QUAD 405 Non-Inverting Input Modification

The Following information is based on PCB type M12565 iss.3. The layout can be applied to other versions but the instructions below may not relate. See pictures at <https://keith-snook.info>

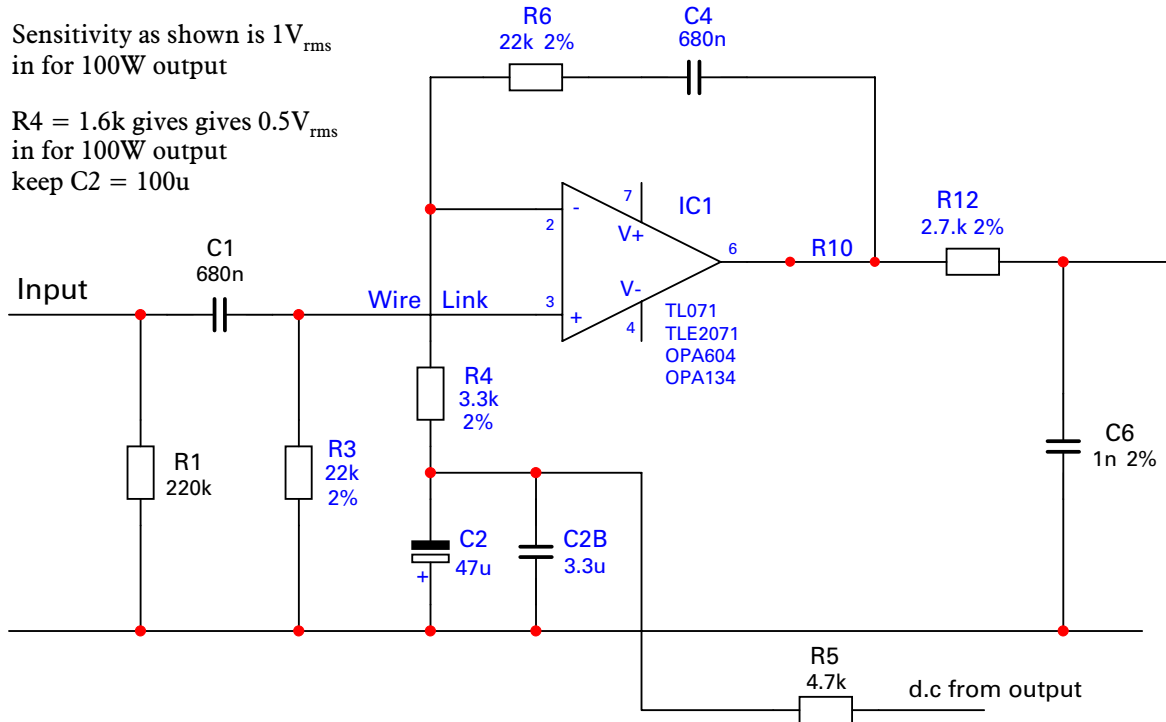
Sensitivity as shown is $1V_{\text{rms}}$
in for $100W$ output

$R4 = 1.6k$ gives $0.5V_{\text{rms}}$
in for $100W$ output
keep $C2 = 100u$

Cut track to op-amp close to pin 3, remove link pins and zenner diodes D8 and D9.

Replace R10 with wire link, fit new values for R4, R6 and C4.

Fit new R3 standing upright such that it bridges R4 and fits between end of C1 and the hole to ground where the link pin was removed.

Fit wire link from op-amp pin 3 to junction C1/R3, this can follow a path against ground track.

Changing R12 to 2.7k inceases the frequency response to about 59kHz but this may not be suitable where the dumpers are "slowed down" in versions where 1nF capacitor is placed across Tr10 BDY77.
